BROAD LANE | TOTTENHAM HALE

NEW OFFICE BUILDING

DESIGN AND ACCESS STATEMENT

DAS ADDENDUM 2 (RESPONSE TO QUALITY REVIEW PANEL)

FIGURE 14 - PROPOSED GROUND FLOOR PARTIAL (AFTER PRE-APP)

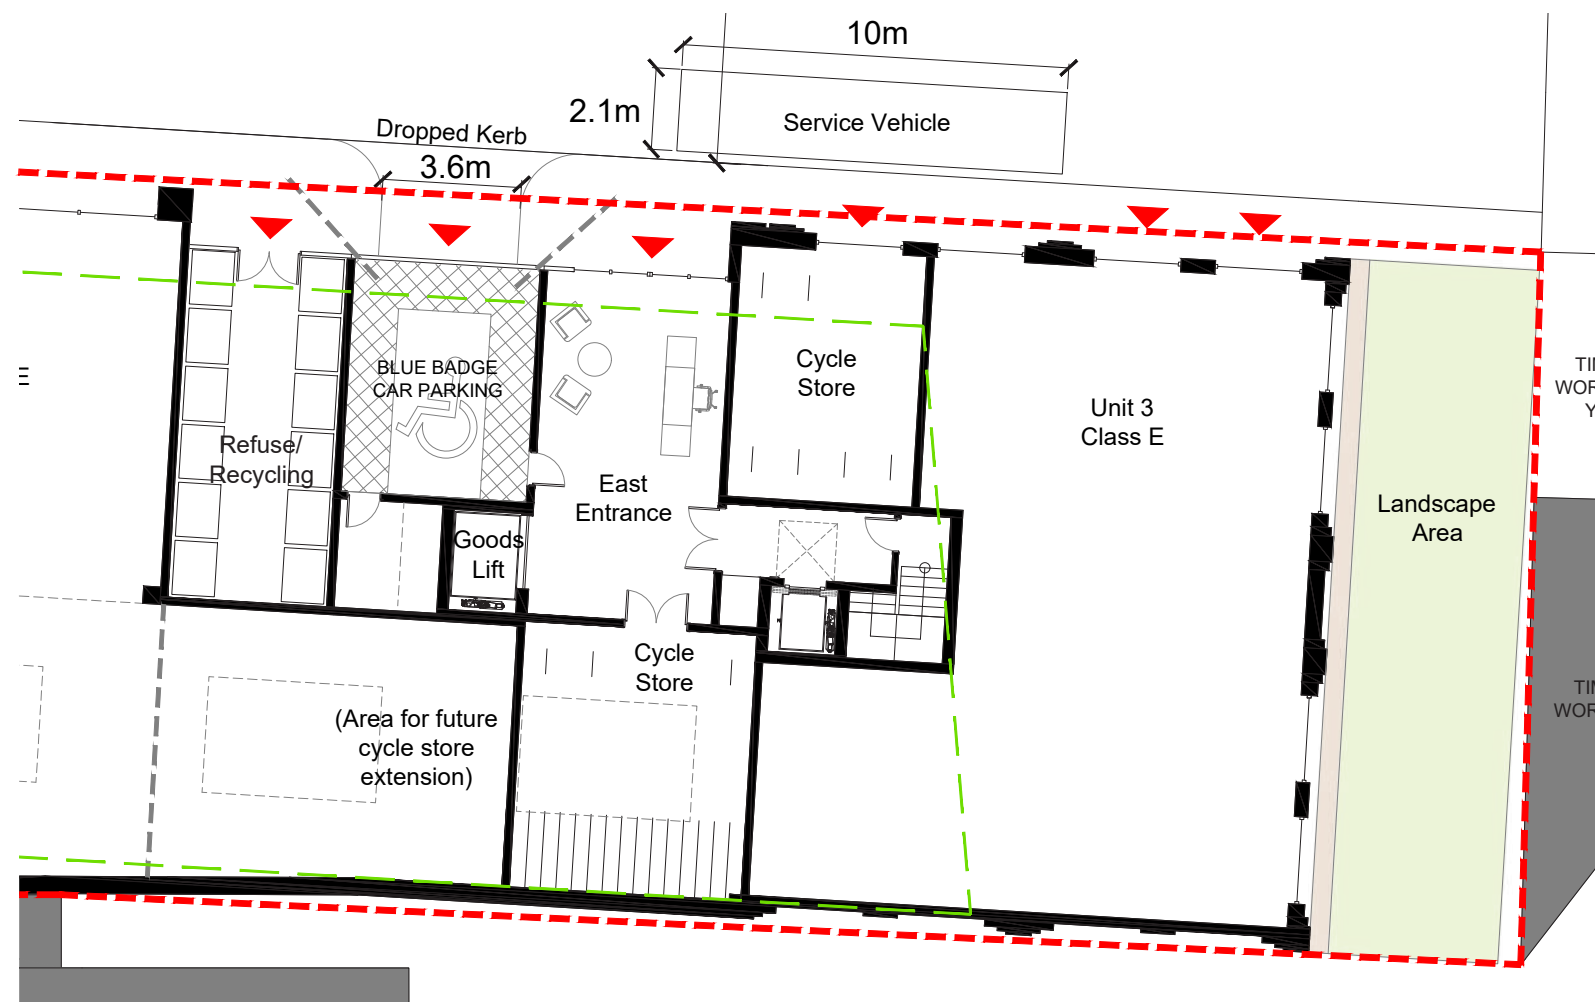
The large cycle parking store containing Sheffield Stands and double stacked has been relocated and is accessed from the east entrance lobby. An adjacent area has been identified as suitable for expanding the capacity of the cycle store.

FIGURE 02 - GREEN ROOF AND PV PANELS

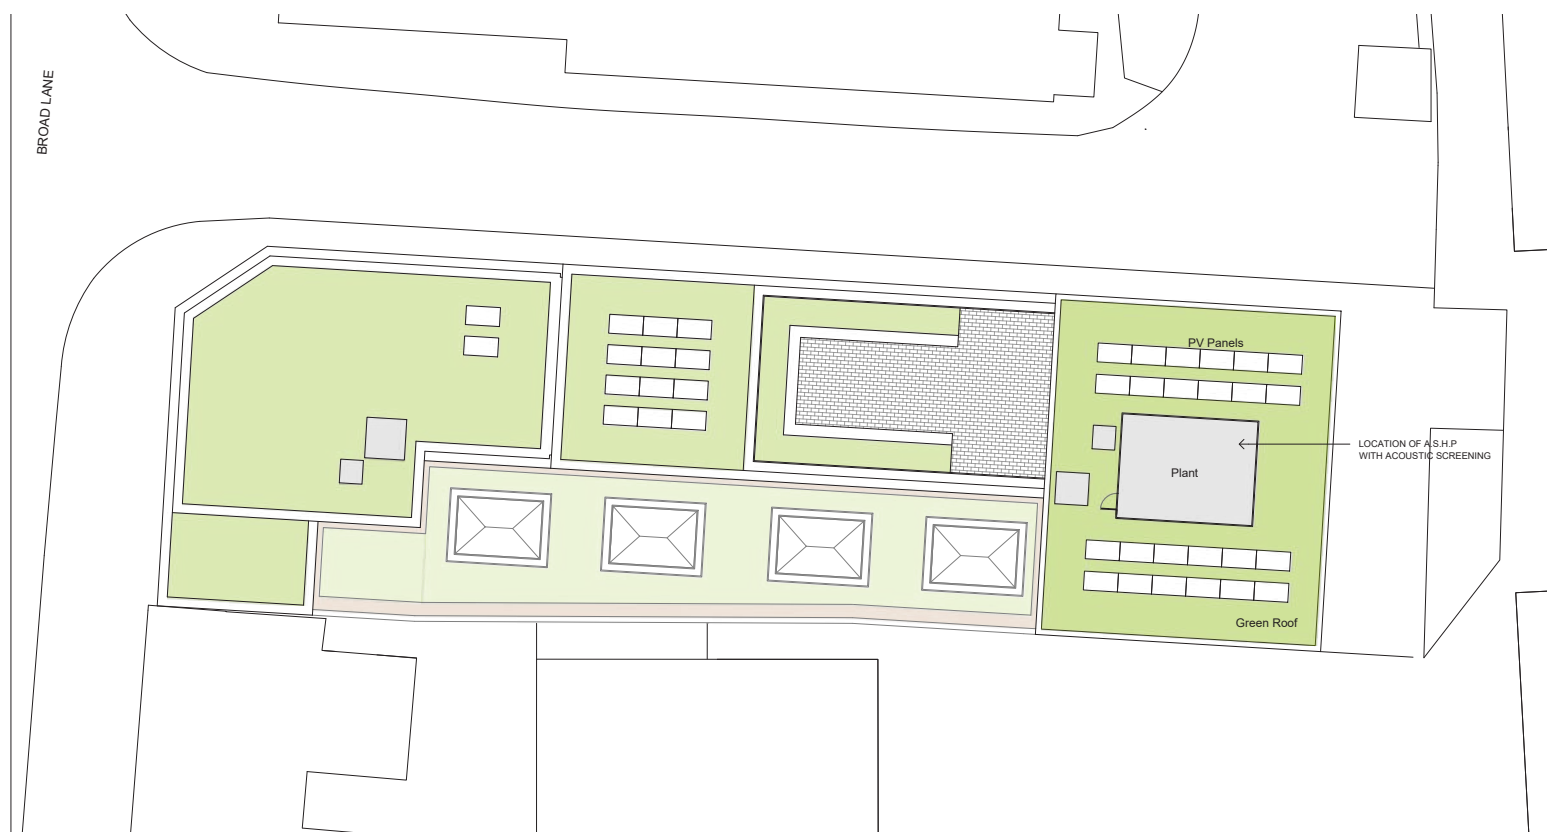
The proposal includes for 712 sq. m. of new green roof that will promote biodiversity, and create habitat for insects, birds and bats. New greenery will add a significant ecological benefit to a site which was previously mostly impermeable hard surfaces (former car wash). The soft landscaping will include and promote native and pollinator plant species.

To the east of the site, at ground level, is a 79 sq. m. area of open soft landscaping including flower rich perennial planting.

FIGURE 06 - ROOF PLAN SHOWING ASHP LOCATION AND PV QUANTUM/LAYOUT

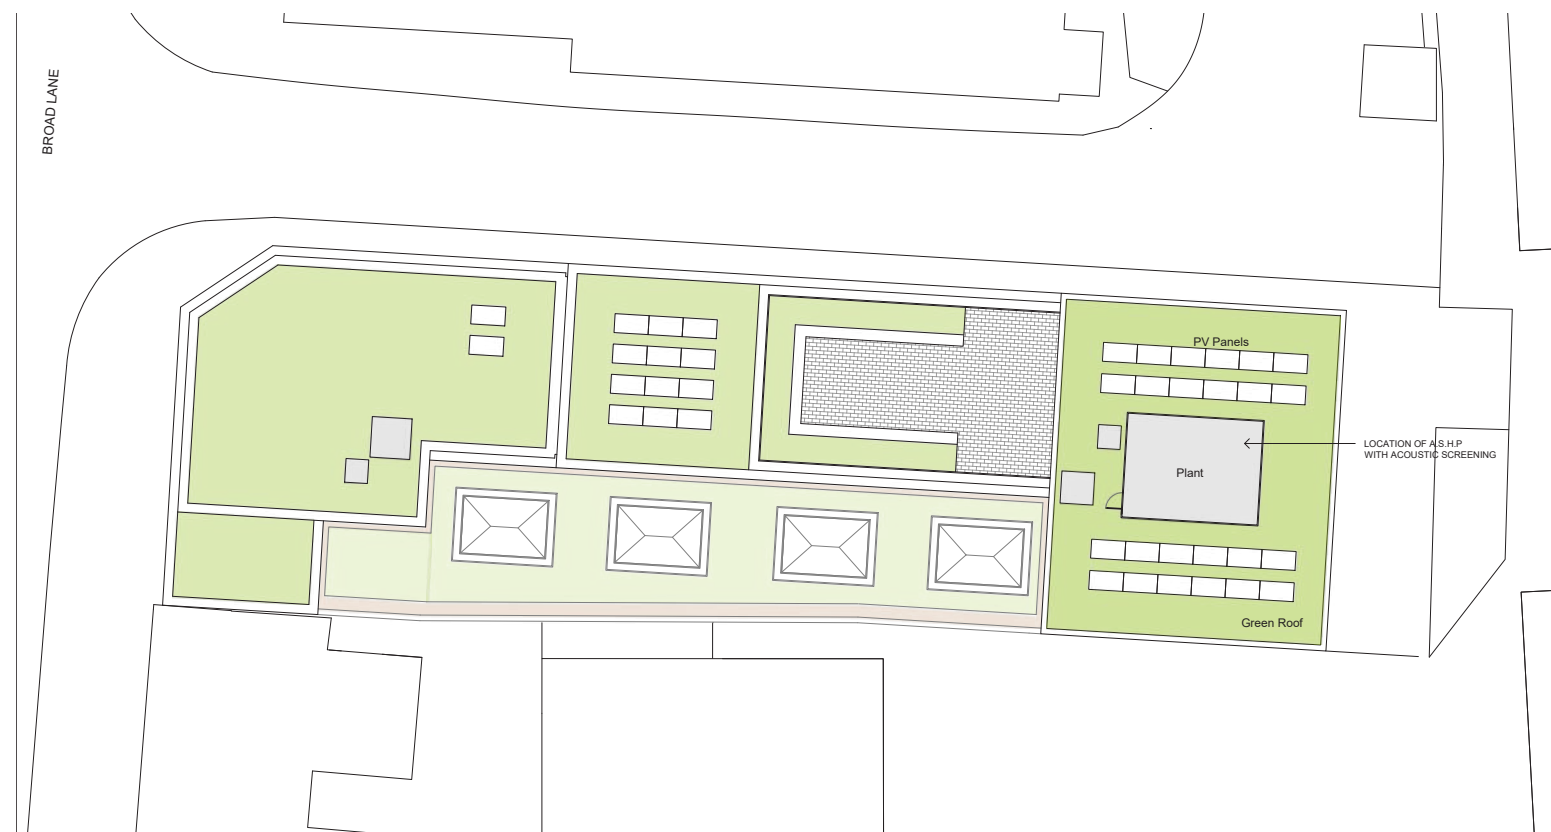
L.B. Haringey requested that additional PV panels be considered to maximise the potential of the roof space. In coordination with an Energy Consultant, a total of 38 PV panels are proposed. Refer to Figure 06 opposite and revised drawing 2106_PL_118 Rev A in the appendix.

The ASHP are located on the roof above the 8th Floor at the east of the site. Sound impact will be mitigated via a continuous surrounding acoustic screening. They are located towards the centre of the floor plate such that the surrounding acoustic screening will be away from the building edge and therefore not visible from nearby street level. Refer to Figure 06 opposite and revised drawing 2106_PL_118 Rev A in the appendix.
